Permit Number: 20-04006

Plan: 1572 AB
Job#: Kitsap Base Plan
Date: 04/08/20
Revision Date:
Drawn by:
Phone: (253) 297-8040

Reviewed for code compliance
with IRC 2015
Kitsap County Building Department
lasmith@co.kitsap.wa.us
10/02/2020

LOWER FLOOR PLAN 'B'

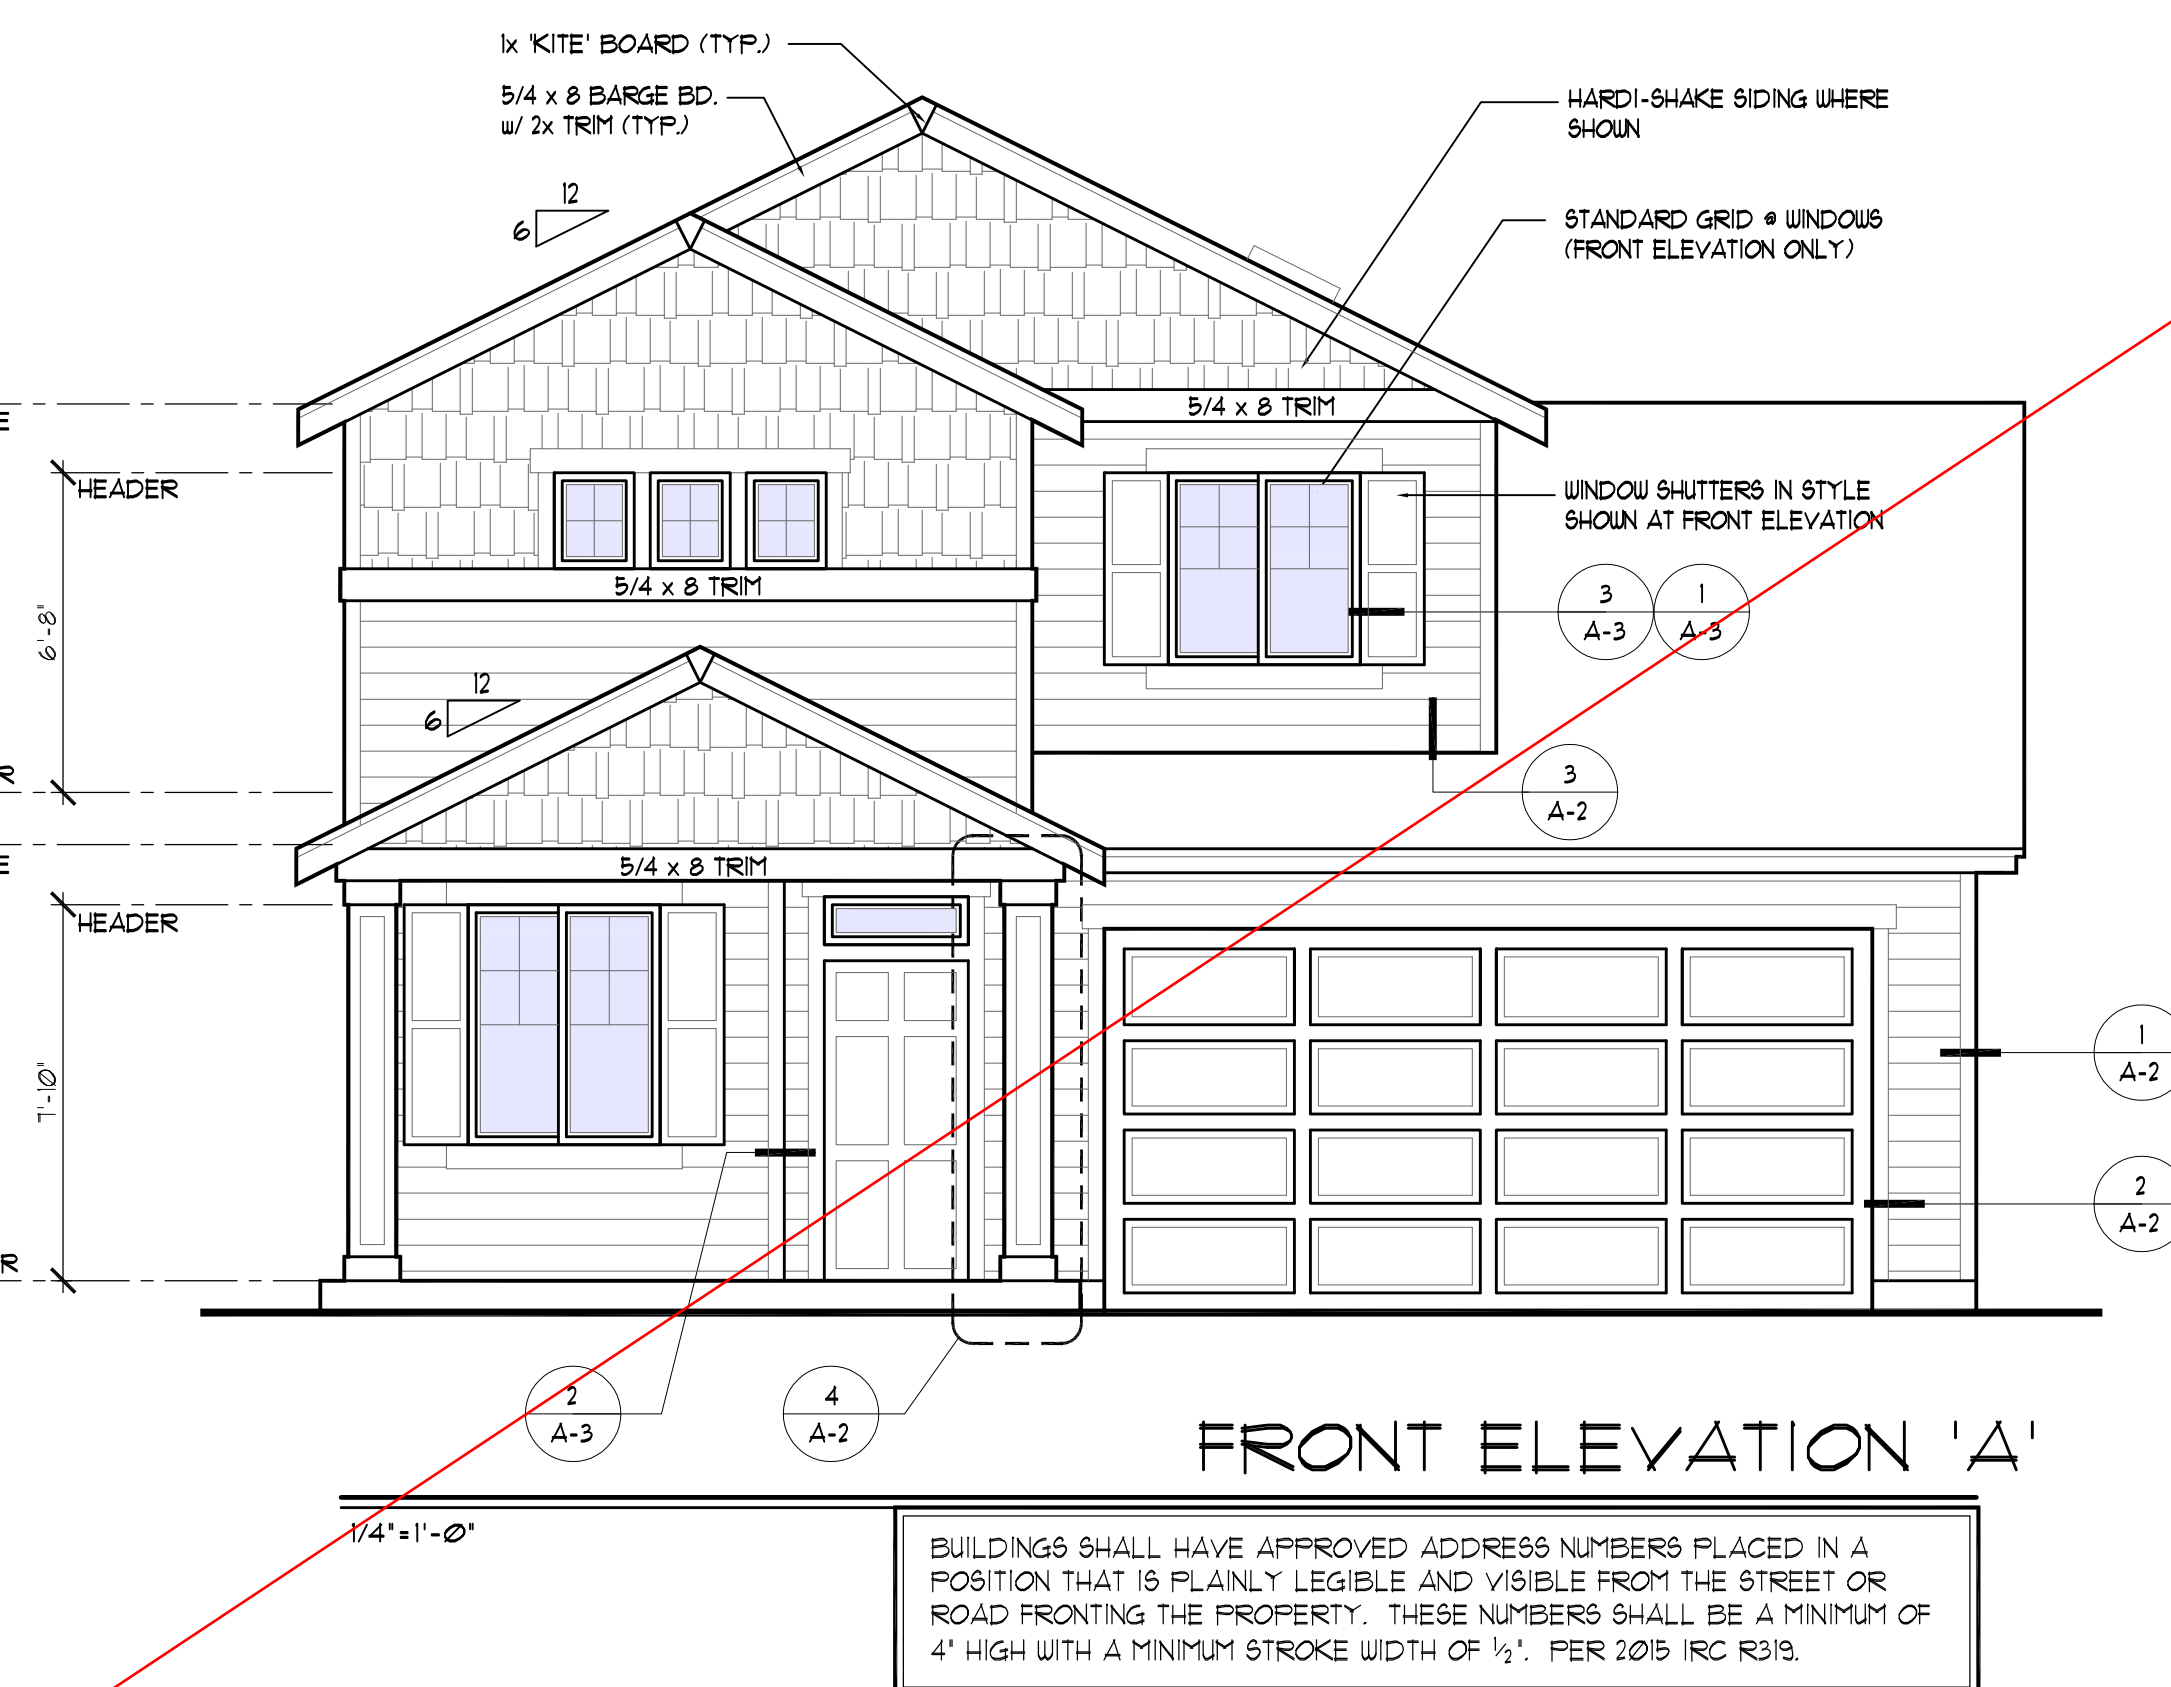
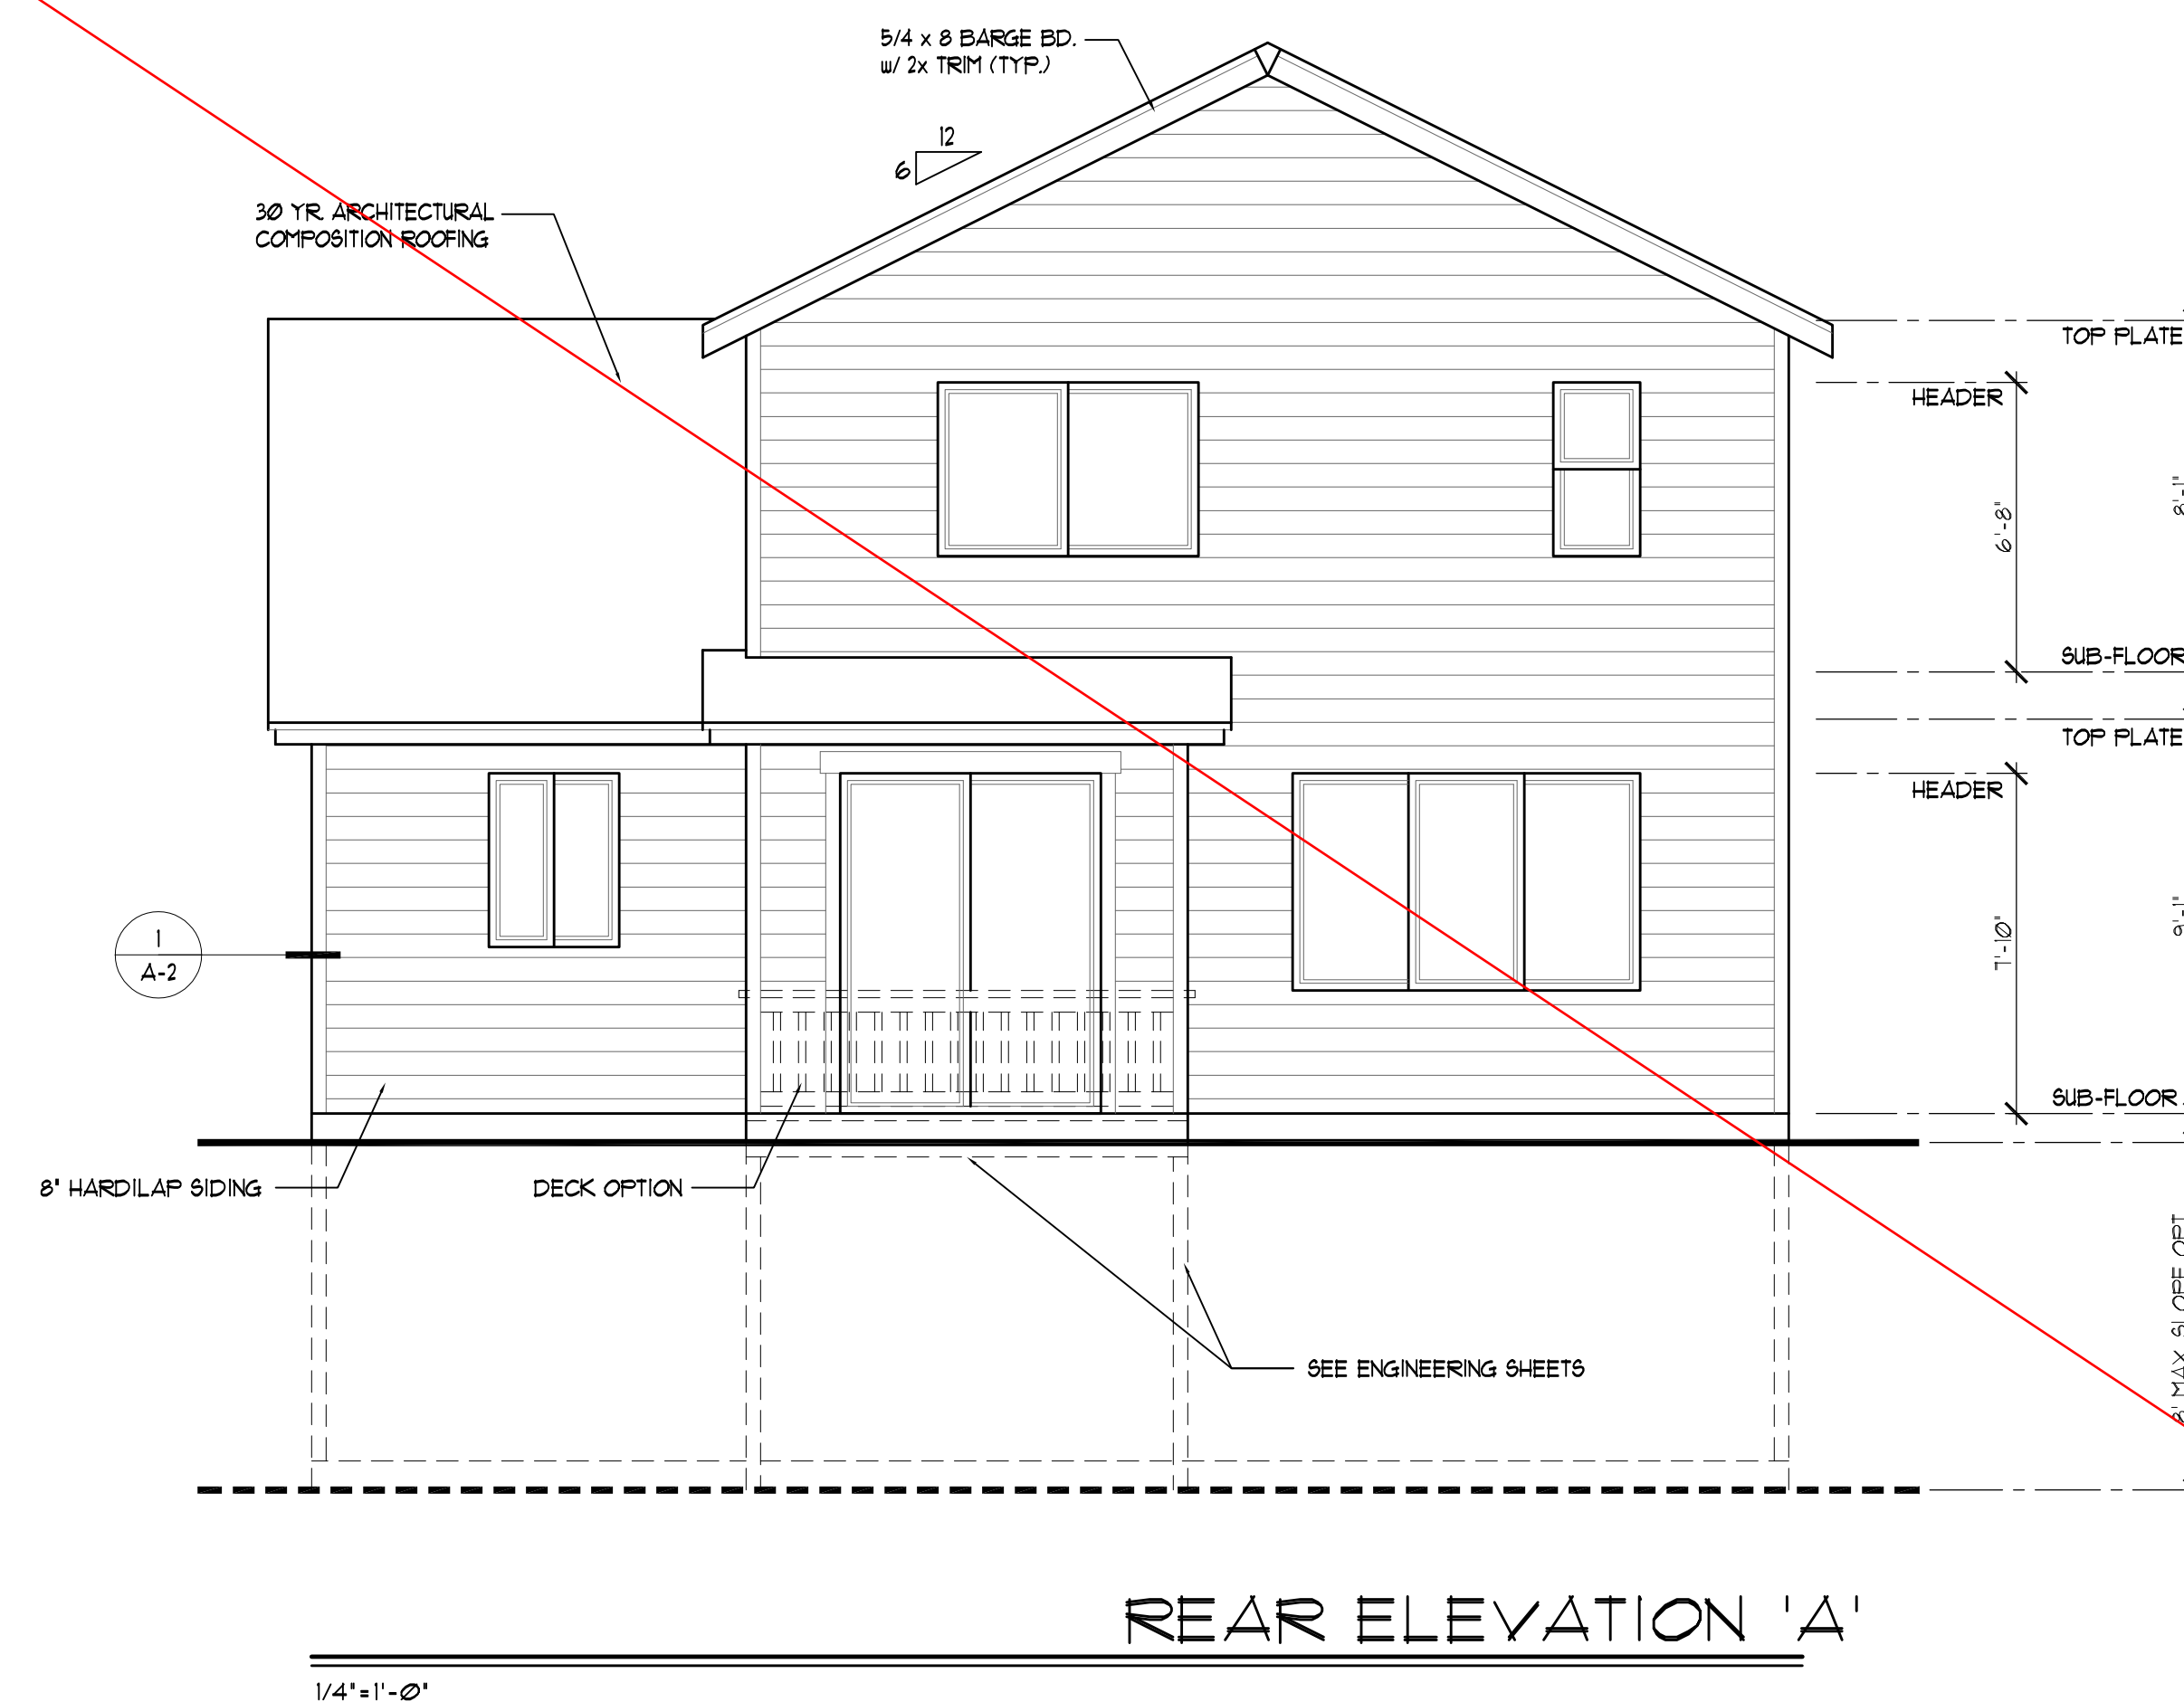
OPENINGS SUCH AS DOORS AND ATTIC ACCESSES SHALL BE 1-3/8" SOLID CORE DOORS, OR A 20-MINUTE RATED ASSEMBLY AND SHALL BE SELF CLOSING AND SELF LATCHING.

ROOF FRAMING/UPPER FLOOR SW PLAN 'A'

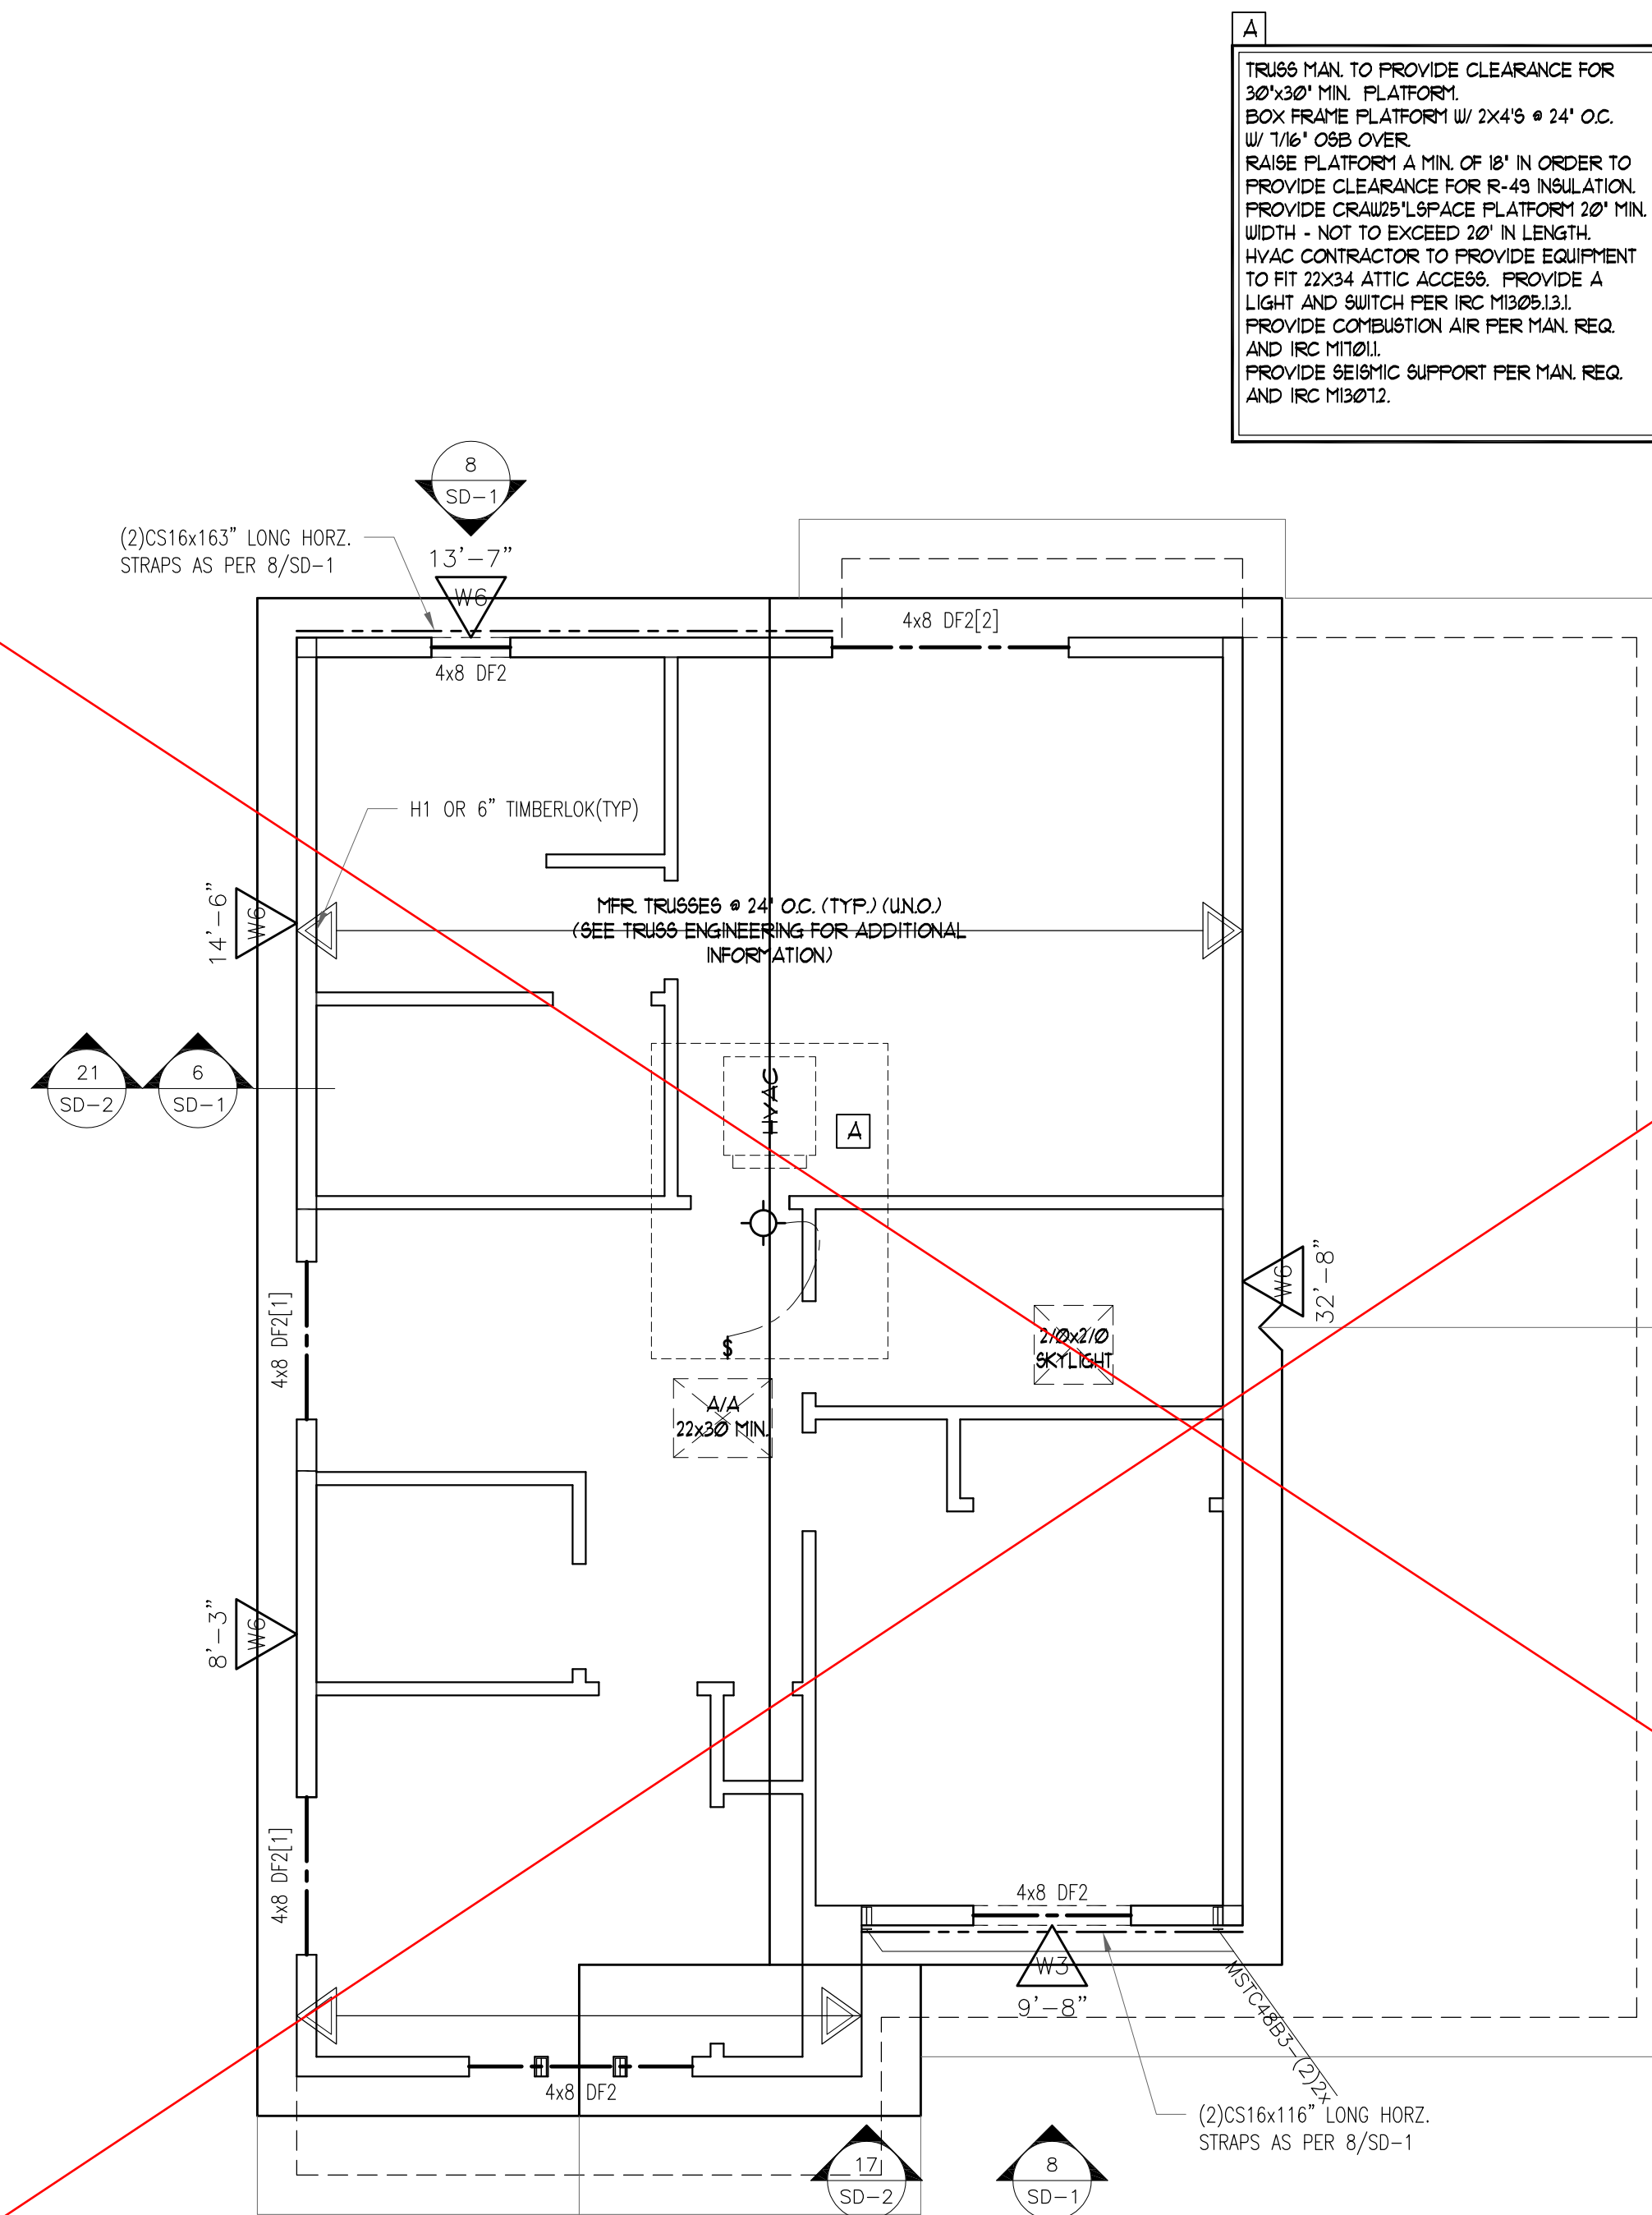
Full manufactured truss engineering shall be available on-site at framing inspection
